DMVA 42240114 – ASPHALT APRON AND CONCRETE PARKING PAD REPAIRS

MUIR AIRFIELD – AREA 19

17 JULY 2025

RFI inquiry received 11 JULY 2025

DMVA Project # 42240144 MUIR AIRFIELD APRON AND PARKING
PAD REPAIR

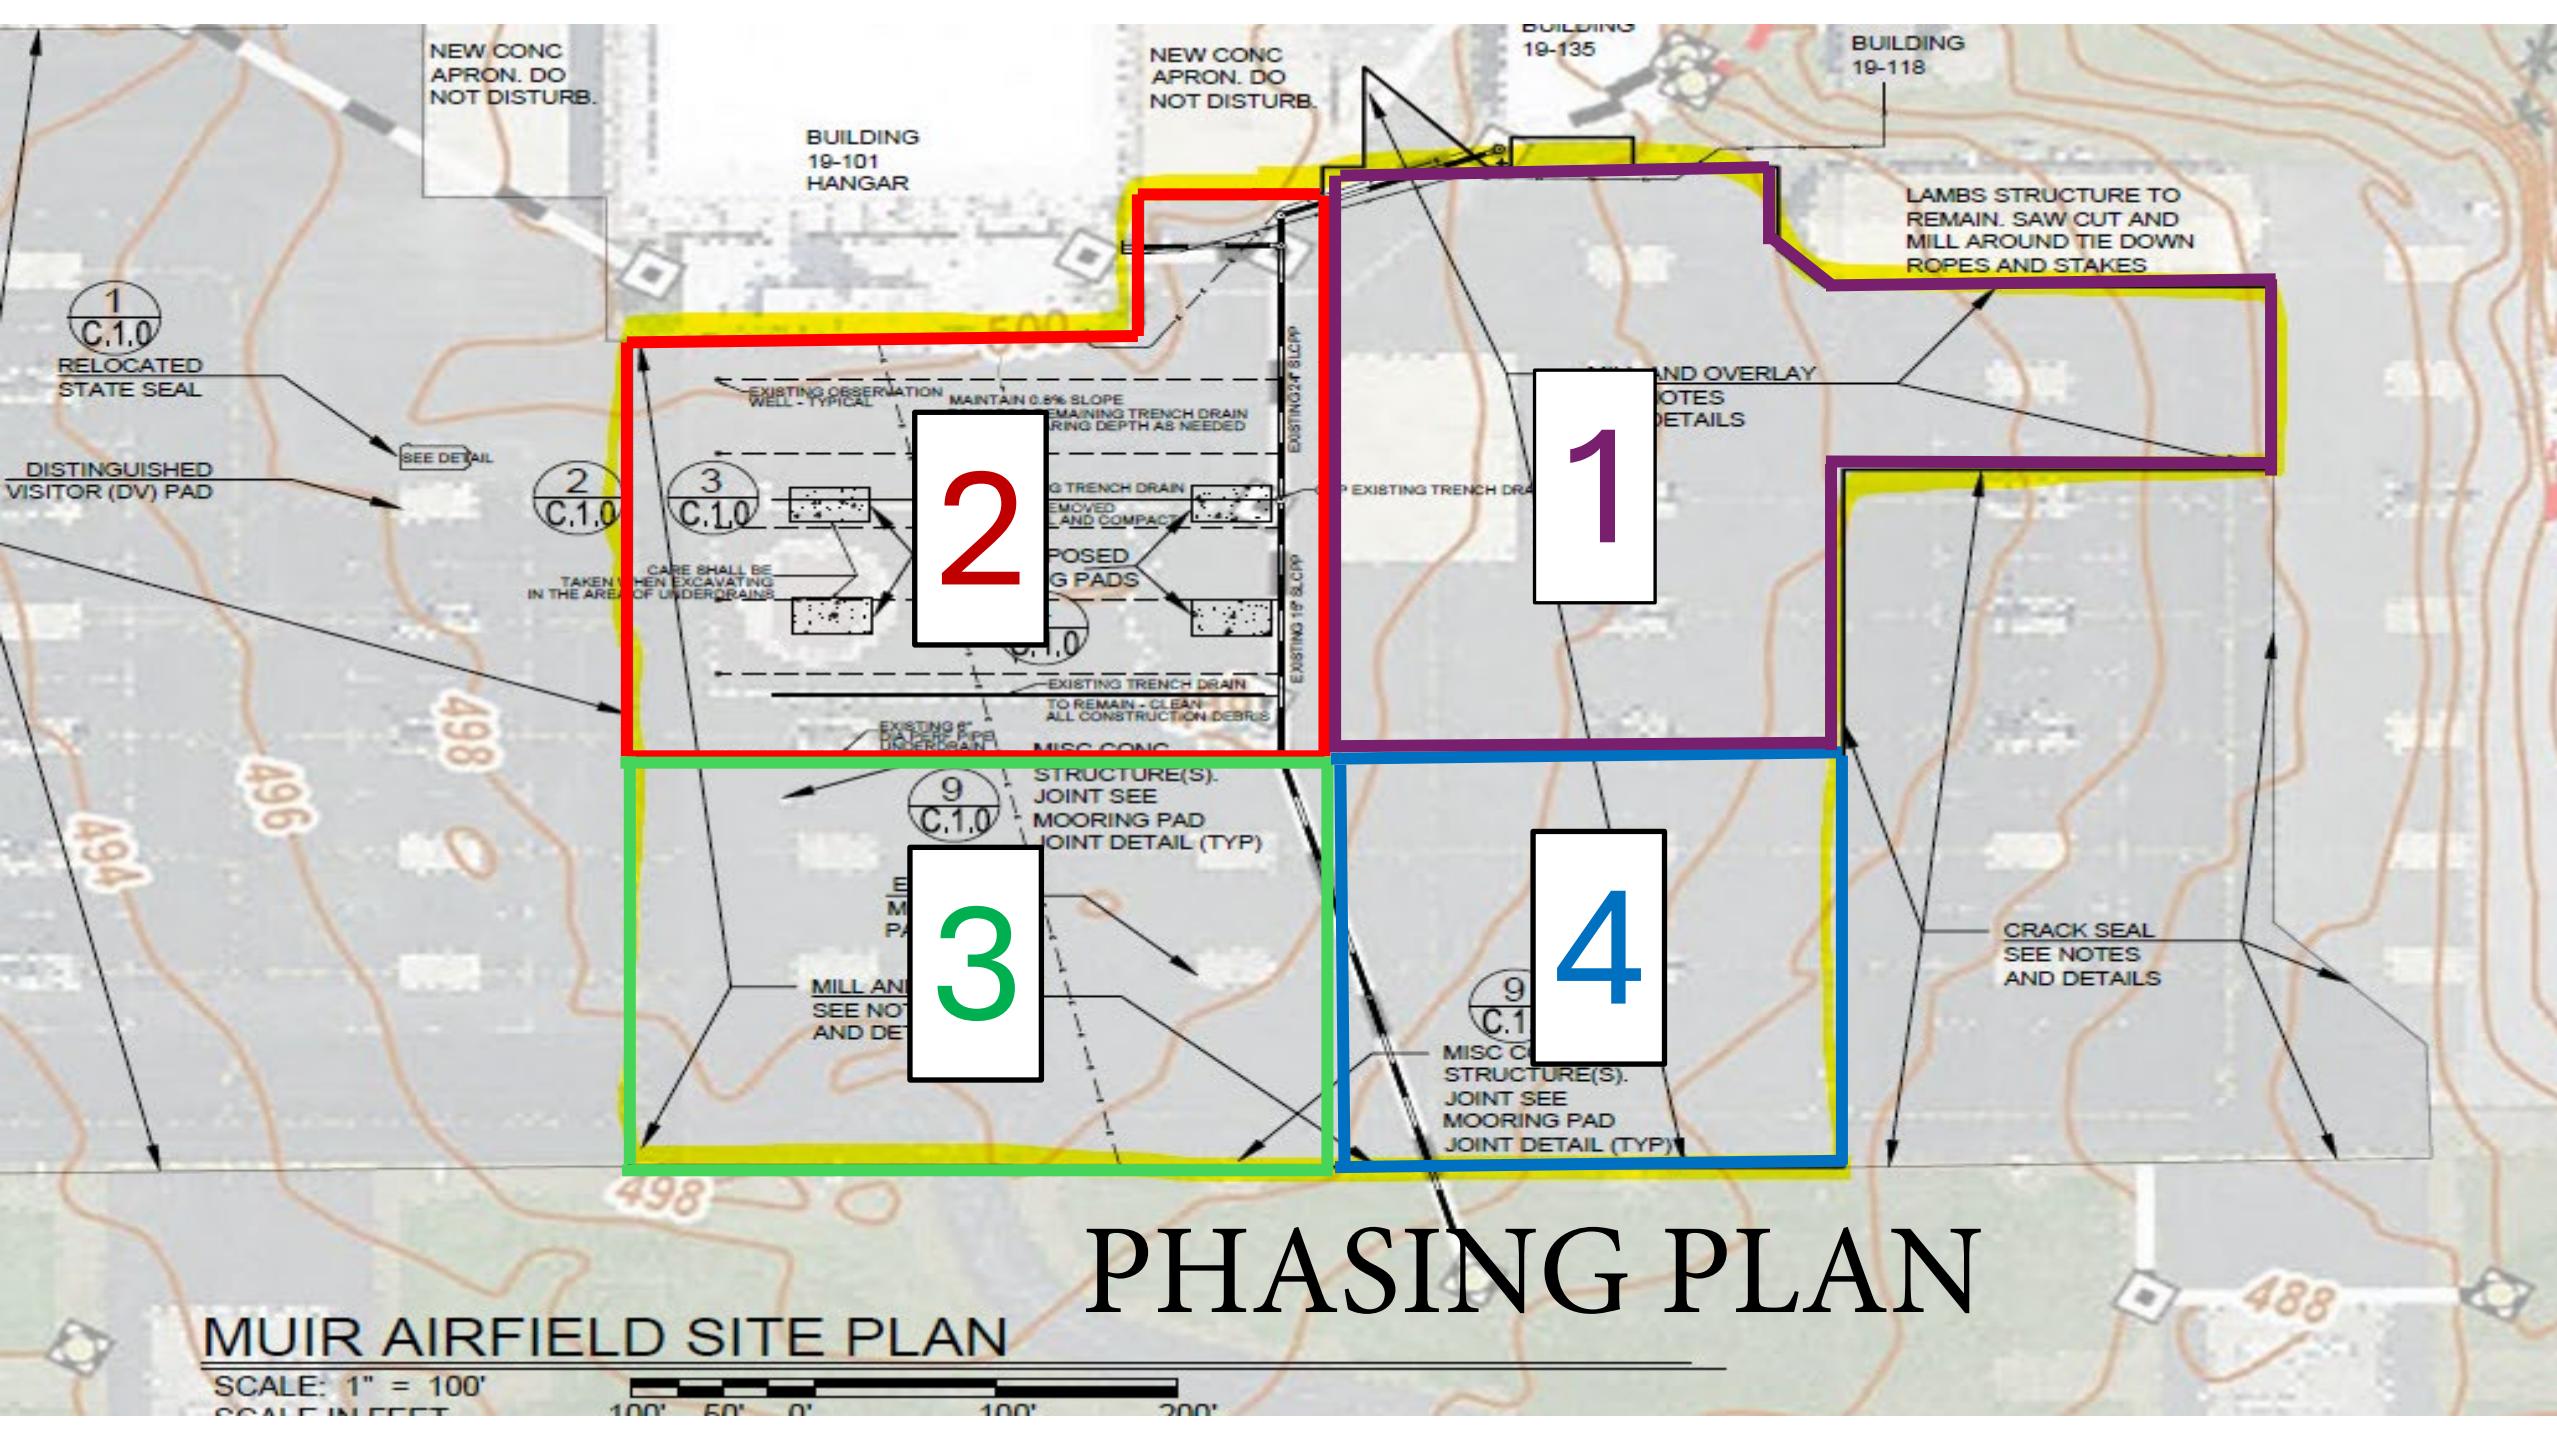
Q2. Please confirm excess spoils are to remain stockpiled on site.

Answer: Milling spoils shall be used to construct the perimeter airfield roadway. The Contractor may not cross the airfield to construct the perimeter road. Millings will need to be removed from the airfield through the gates on the north-east side of the hanger (19-101) and transported via FTIG roads to the south side of the airfield. The Fire Station Gate and the Northwest Gate may be used for access to construct the roadway.

Additional milling spoils and concrete trench drain shall be disposed of at the Johnson Trail site, east of the project. Spoils shall be placed in the stockpiles indicated by DIM and should not be mixed.

1. The dump site for the excess millings is located on Johnson Trail and identified by the YELLOW STAR. Directions from AF: Use East exit from AF. Turn Right onto Range Rd. Turn Right onto Johnson Trail. Dump site on the Left.

2. The South Gate Entrance (Fire Dept Ent) is identified by a BLUE ARROW.
Directions from AF:
Exit from AF. Turn Left onto Range Rd. Turn Left onto Utility Rd. Turn Left onto Clements Ave. Merge Left onto Fisher Ave. Gate is on the Left Across from the Fire Dept.

3. The West Gate Entrance is identified by an ORANGE ARROW.
Directions from AF:
Exit from AF. Turn Left onto Range Rd. Turn Left onto Unnamed Gravel Rd. Turn Left to the gate.

Figure 7-13. Type 1 Parking for all Rotary Wing Aircraft Except CH-47

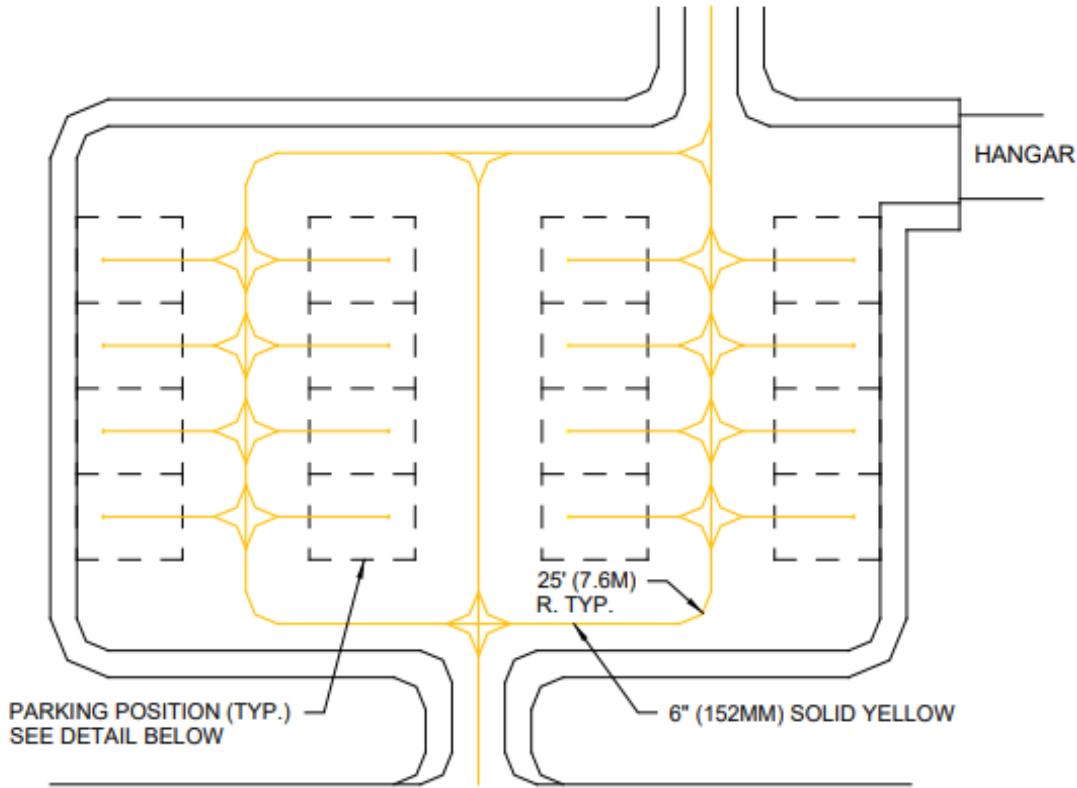
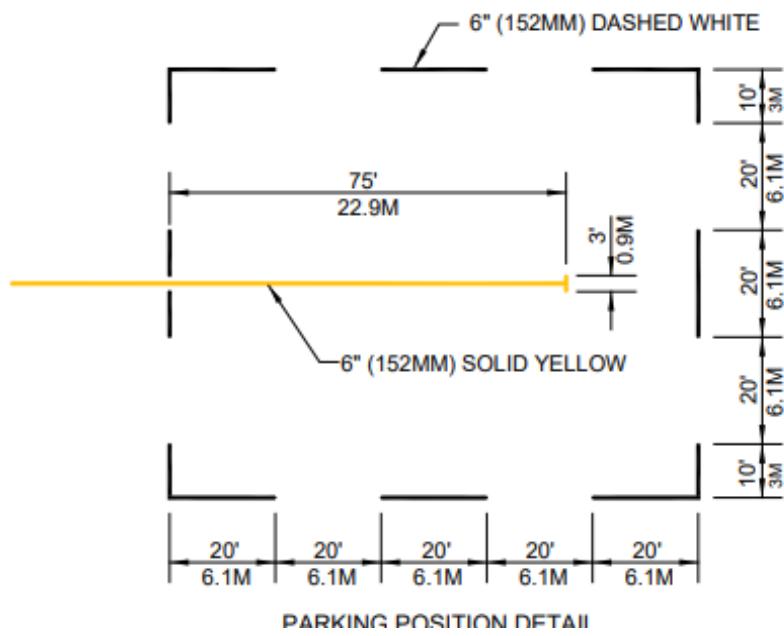
Q4. Please provide a proposed line striping plan. The existing lines are difficult to read on the plans.

Answer: A PAINTING EXHIBIT, specification, and standard detail are attached. UFC-3-260-04 (Dated 16 May 2018) Figure 7-13 Type 1 Parking for all Rotary Wing Aircraft Except CH-47. Continue the yellow taxiway line all the way through the parking pads, since our parking layout allows pull-through to the adjacent interior taxi lane.
